**STATE OF VERMONT
AGENCY OF TRANSPORTATION**

**PROPOSED IMPROVEMENT
RAIL PROJECT
COUNTY OF ADDISON
TOWN OF NEW HAVEN**

RECORD PLANS

PROJECT NUMBER : RAIL 5307 (16)

QUANTITY SHEET 1

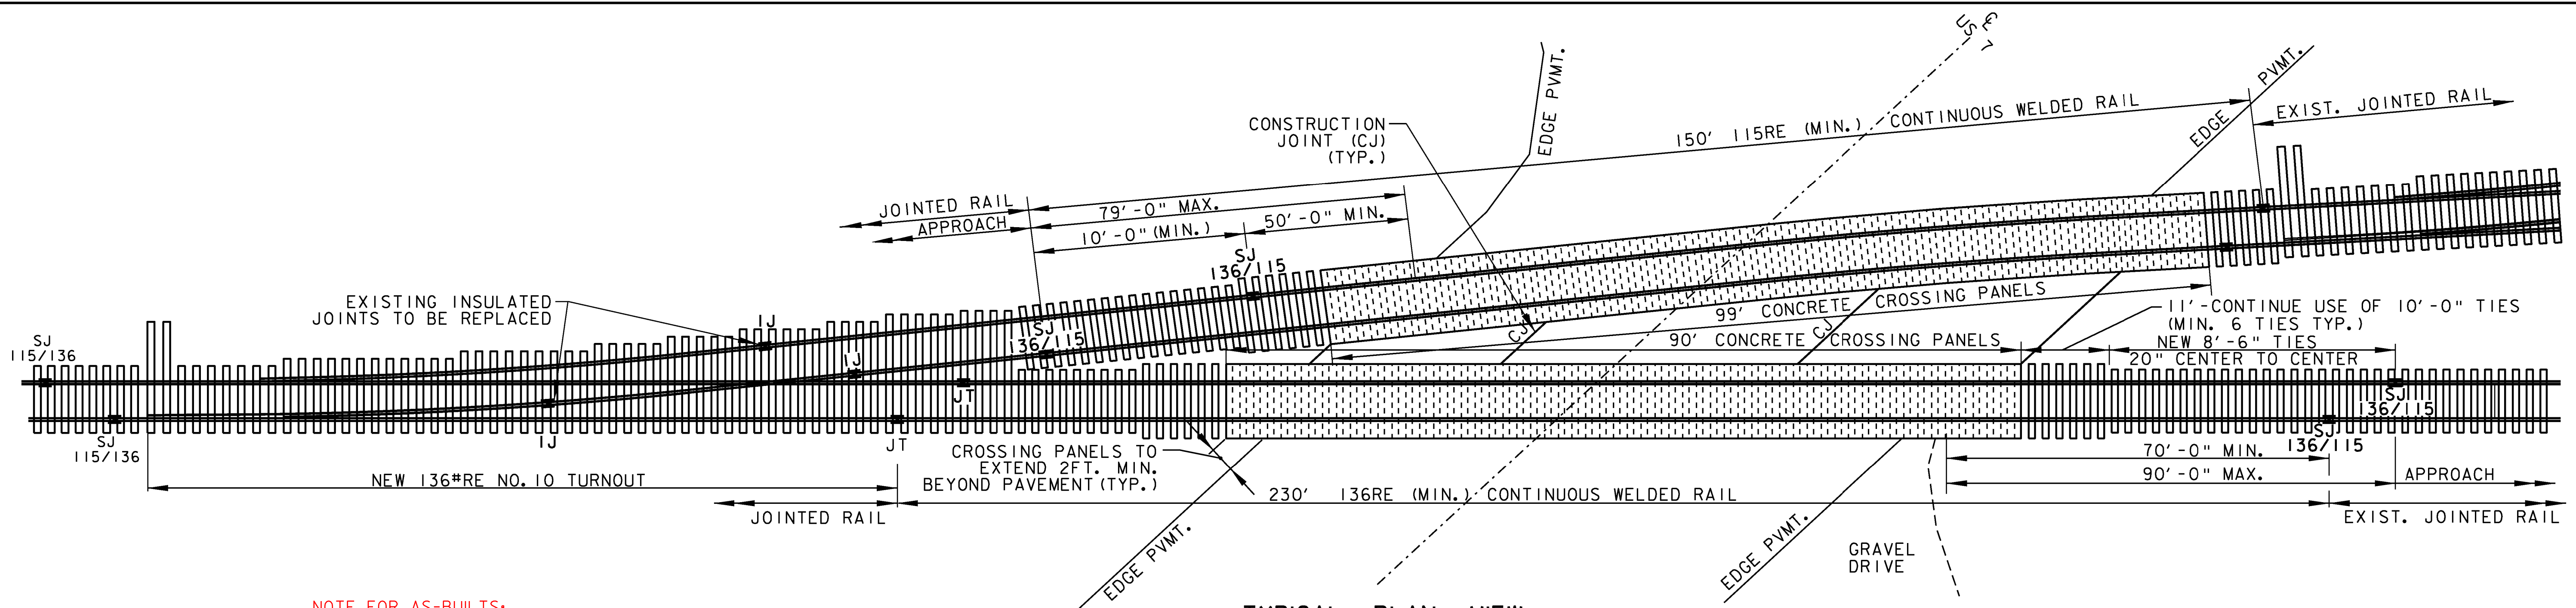
SUMMARY OF ESTIMATED QUANTITIES										TOTALS		DESCRIPTIONS				DETAILED SUMMARY OF QUANTITIES			
							ROADWAY	EROSION CONTROL	RAILROAD	FULL C.E. ITEMS	GRAND TOTAL	FINAL	UNIT	ITEMS	ITEM NUMBER	ROUND	QUANTITIES	UNIT	ITEMS
							120		90		210		CY	COMMON EXCAVATION	203.15				
							55				55		CY	EXCAVATION OF SURFACES AND PAVEMENTS	203.28				
							120				120		CY	EARTH BORROW	203.30				
							1				1		CY	TRENCH EXCAVATION OF EARTH, EXPLORATORY (N.A.B.I.)	204.22				
							750				750		SY	COLD PLANING, BITUMINOUS PAVEMENT	210.10				
							15				15		CY	AGGREGATE SURFACE COURSE	401.10				
							2				2		CWT	EMULSIFIED ASPHALT	404.65				
							1				1		LU	PRICE ADJUSTMENT, ASPHALT CEMENT (N.A.B.I.)	406.50				
							22				22		CY	CONCRETE, HIGH PERFORMANCE CLASS AA	501.32				
							70				70		LB	EPOXY COATED REINFORCING STEEL QTY ADDED SEE SHEET 5 FOR DETAILS	507.17				
							10				10		MGAL	DUST CONTROL WITH WATER	609.10

0.25				0.25		TON	DUST AND ICE CONTROL WITH CALCIUM CHLORIDE	609.15				
							4				4		EACH	ENERGY ABSORPTION ATTENUATOR	621.56				
							510				510		LF	REMOVE AND RESET GUARDRAIL	621.75				
							370				370		LF	TEMPORARY TRAFFIC BARRIER	621.90				
							80				80		HR	UNIFORMED TRAFFIC OFFICERS	630.10				
							80				80		HR	FLAGGERS	630.15				
										1	1		LS	FIELD OFFICE, ENGINEERS	631.10				
										1	1		LS	TESTING EQUIPMENT, CONCRETE NOT USED	631.16				
										3000	3000		DL	FIELD OFFICE TELEPHONE (N.A.B.I.) NOT USED	631.26				
							1				1		LS	MOBILIZATION/DEMOBILIZATION	635.11				
							1				1		LS	TRAFFIC CONTROL	641.10				
							4				4		EACH	PORTABLE CHANGEABLE MESSAGE SIGN	641.15				
							4150				4150		LF	DURABLE 4 INCH WHITE LINE, THERMOPLASTIC	646.402				
							8400				8400		LF	DURABLE 4 INCH YELLOWLINE, THERMOPLASTIC NOT USED TY I TAPE INCLUDED	646.412				
							300				300		LF	DURABLE 6 INCH WHITE LINE, THERMOPLASTIC BY C.O. #2. SEE SHEET	646.422

TYPICAL PLAN VIEW
N.T.S.

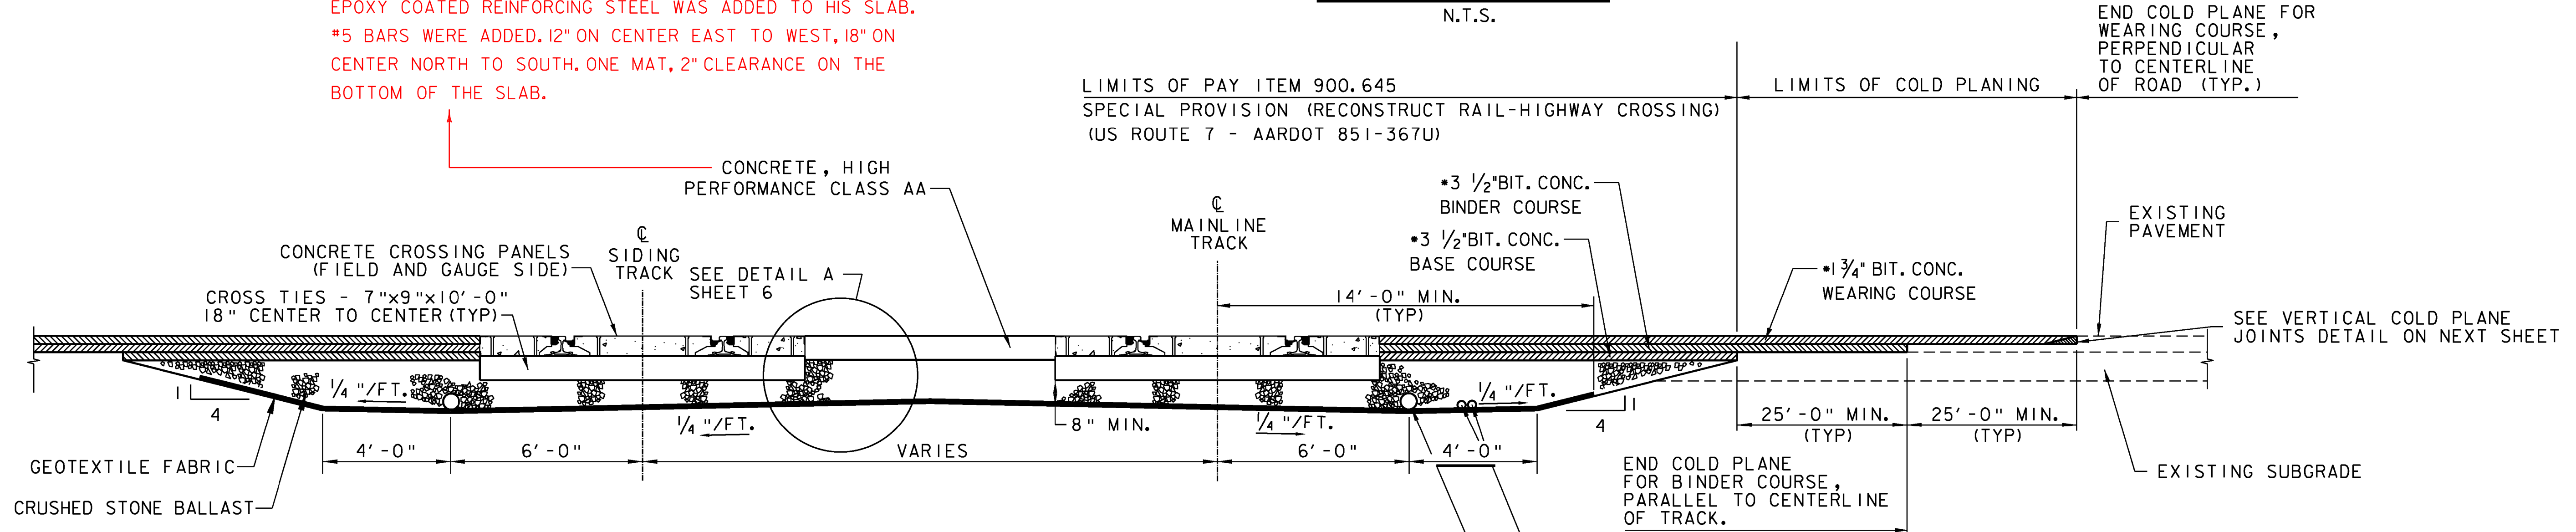
NOTE FOR AS-BUILTS:
EPOXY COATED REINFORCING STEEL WAS ADDED TO HIS SLAB.
#5 BARS WERE ADDED. 12" ON CENTER EAST TO WEST, 18" ON CENTER NORTH TO SOUTH. ONE MAT, 2" CLEARANCE ON THE BOTTOM OF THE SLAB.

FINAL ROADWAY PAVEMENT MARKINGS
 N. T. S

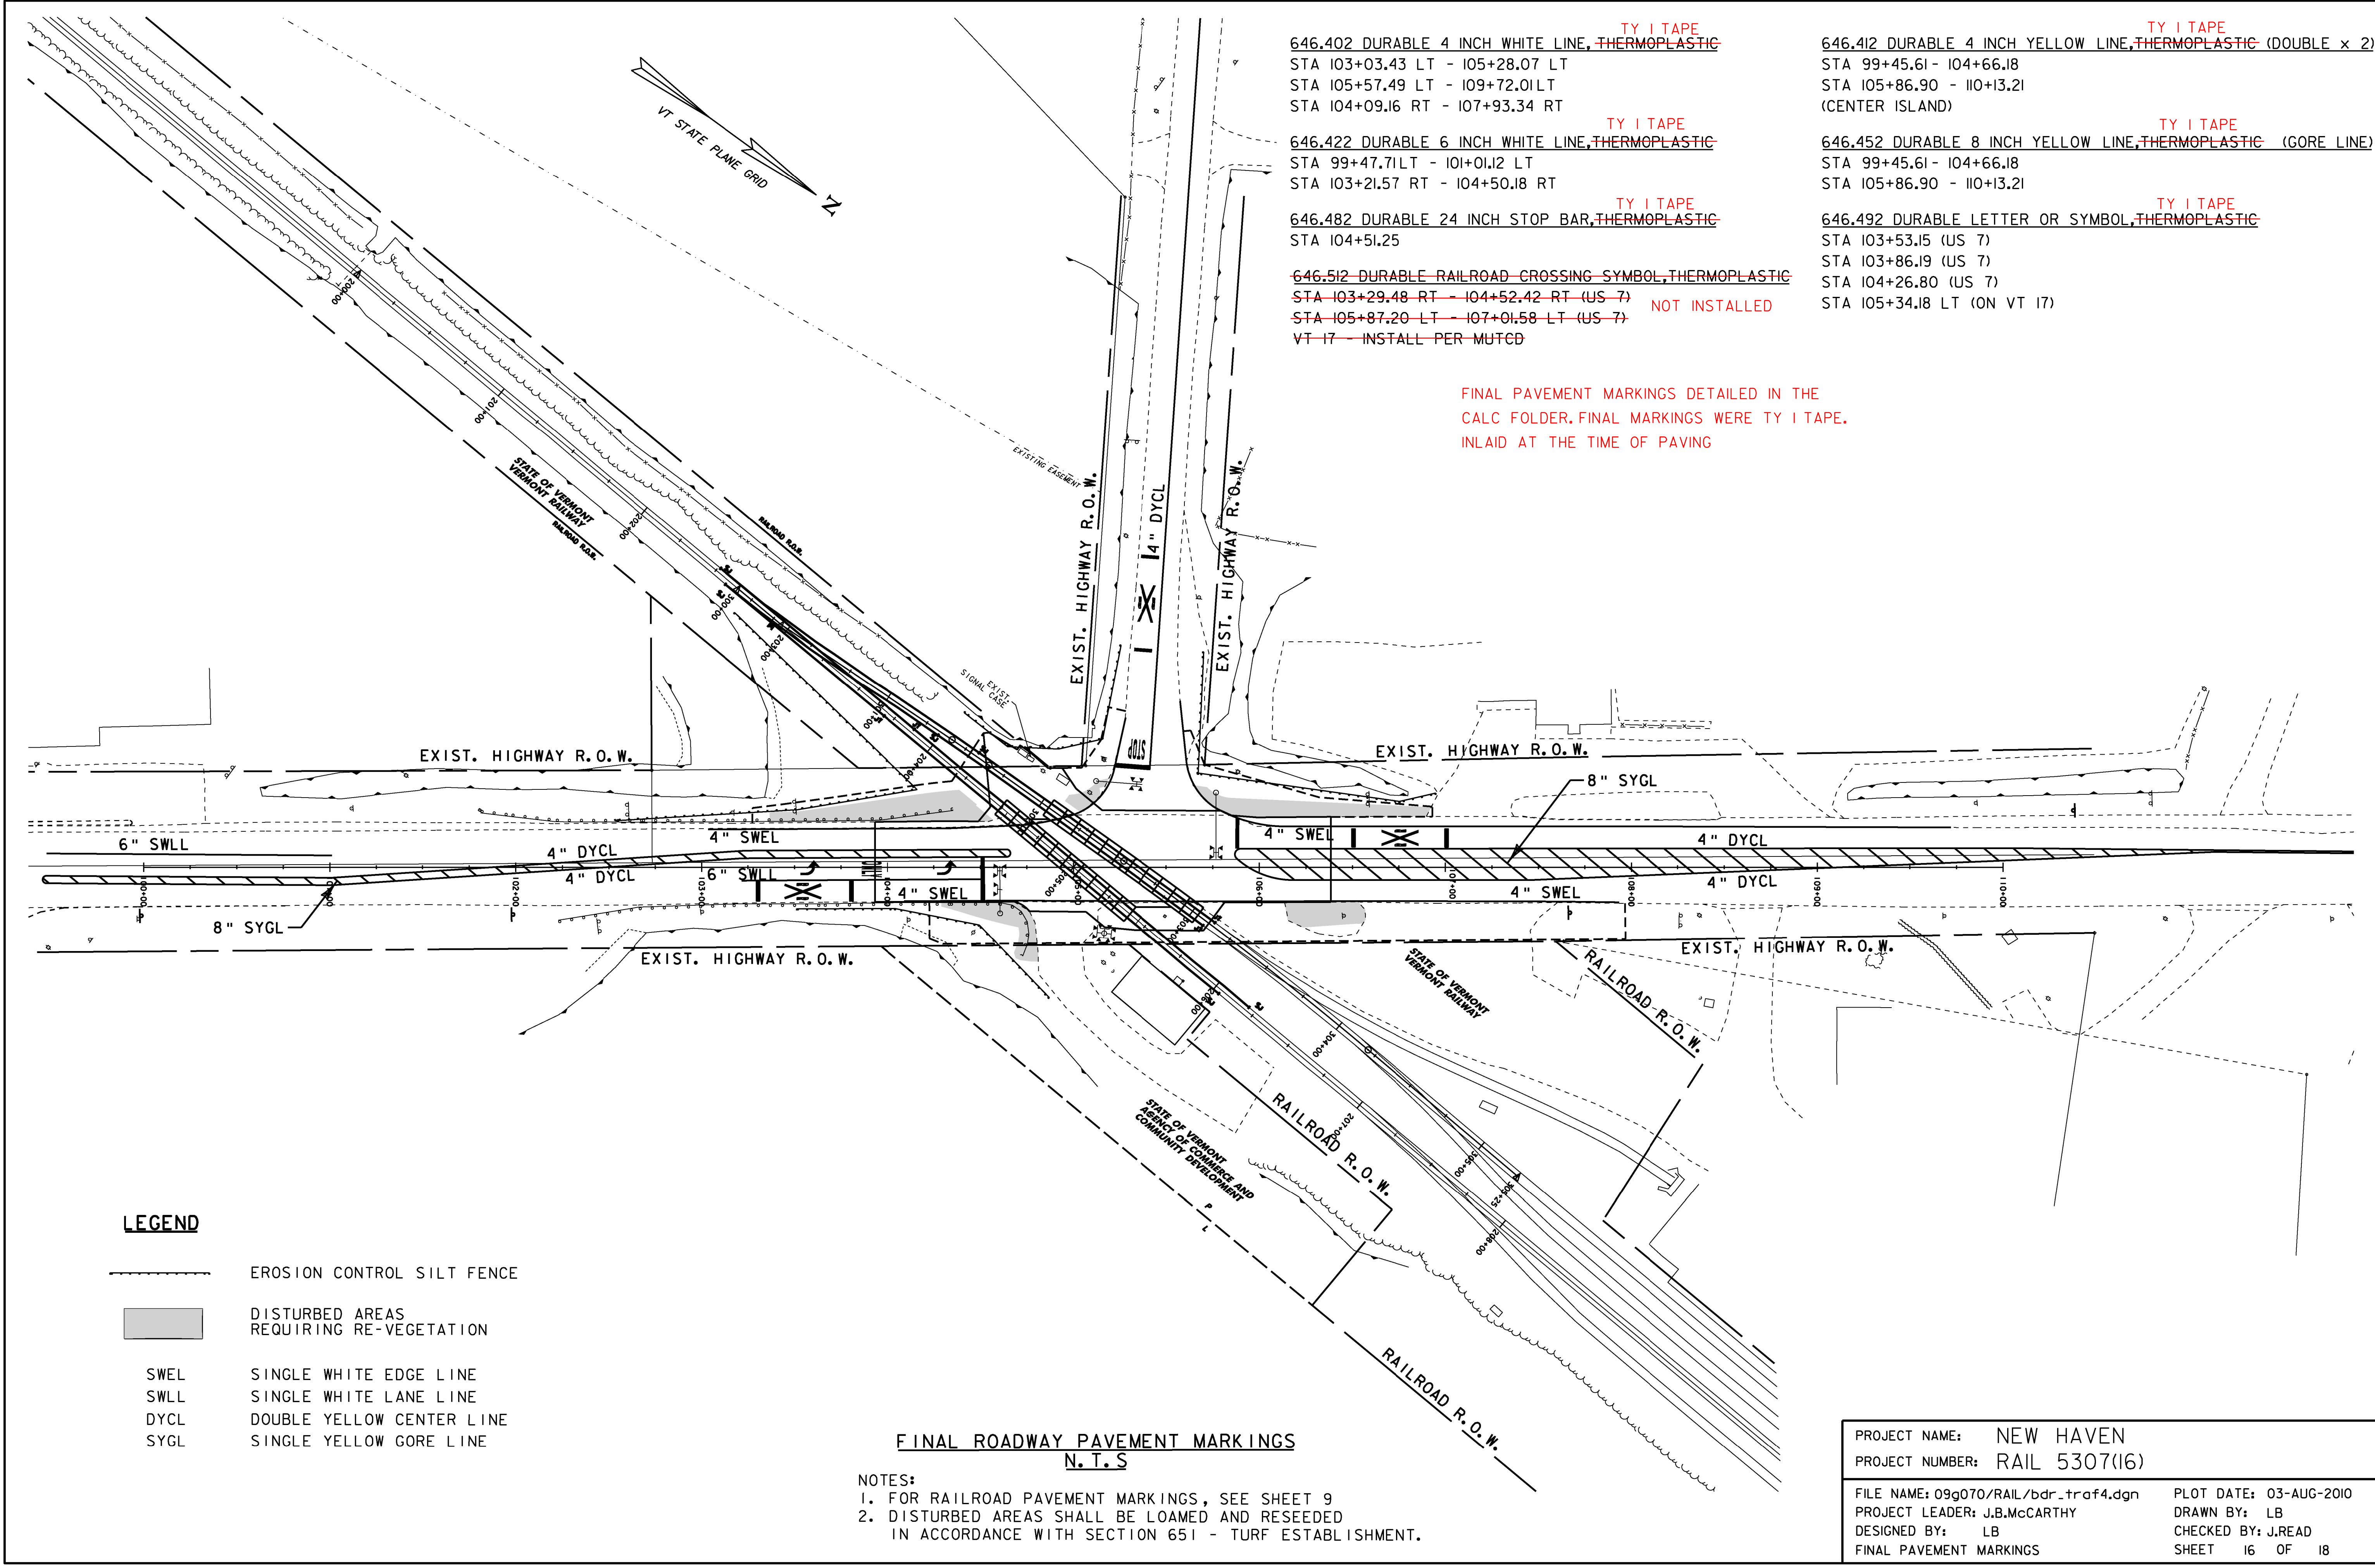
~~646,512 DURABLE RAILROAD CROSSING SYMBOL, THERMOPLASTIC~~
~~STA 103+29.48 RT - 104+52.42 RT (US 7)~~ NOT INSTALLED
~~STA 105+87.20 LT - 107+01.58 LT (US 7)~~
 VT-17 - INSTALL PER MUTCD

FINAL PAVEMENT MARKINGS DETAILED IN THE
 CALC FOLDER. FINAL MARKINGS WERE TY I TAPE,
 INLAID AT THE TIME OF PAVING
